ADDENDUM NO. 1

Project No. 11-13

Nettleton Avenue Neighborhood Storm Drain Improvements Phase 1
Borough of Naugatuck, CT

April 18, 2011

DETAIL 3 SHEET C-601

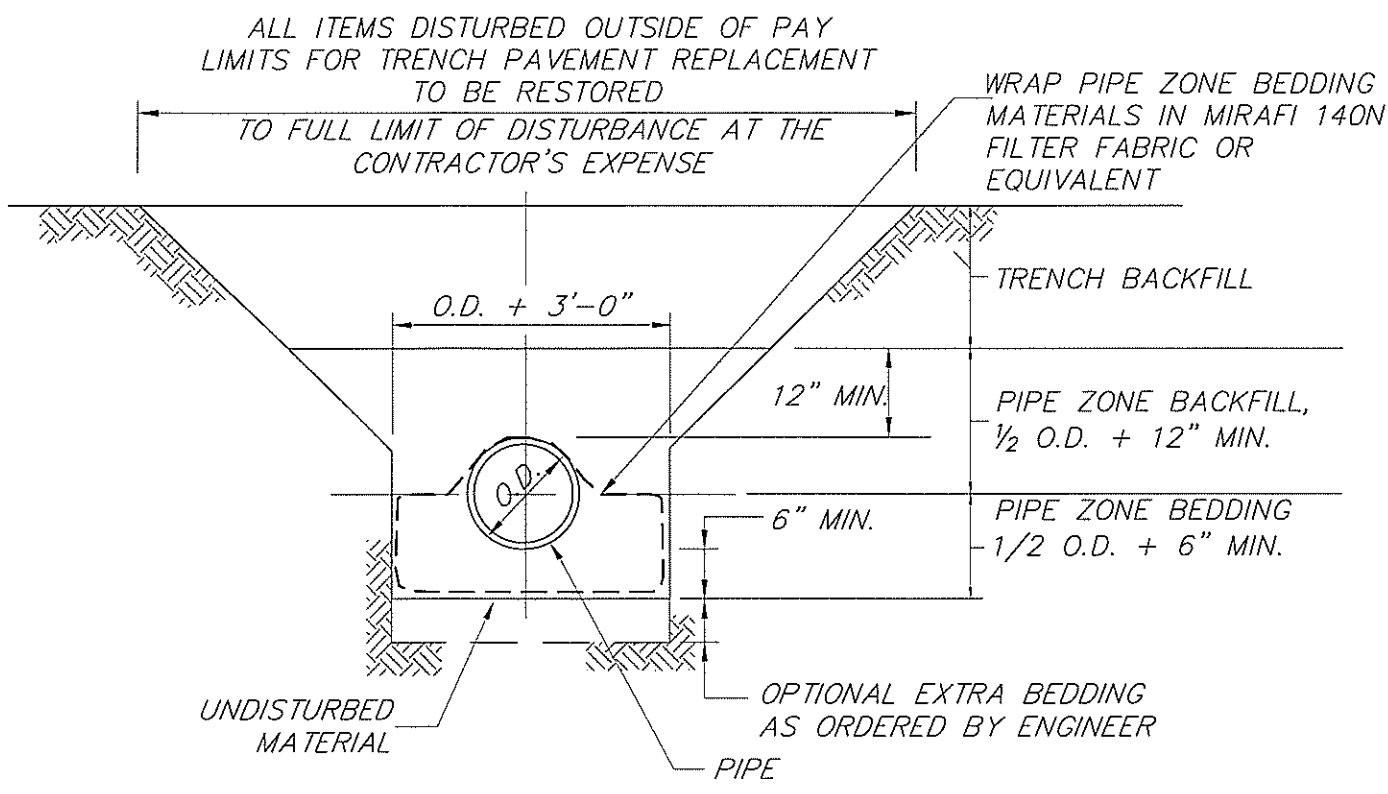
- A1.3 Add technical section 02611 Reinforced Concrete Pipe
- A1.4 Add technical section 02620 Aluminized Corrugated Steel Pipe
- A1.5 Replace Detail 3 Typical Drainage Ditch Detail on plan sheet C-601 with attached Detail 3 Typical Drainage Ditch Detail dated 4/18/11.

1. BACKFILL FOR ALL PIPE TRENCHES SHALL BE PLACED IN LOOSE LIFTS NOT TO EXCEED 6 INCHES IN THICKNESS, PRIOR TO COMPACTION.
2. BACKFILL FOR ALL PIPE TRENCHES SHALL BE COMPACTED TO A MINIMUM DRY DENSITY OF 95% OF AASHTO T-99 STANDARD.
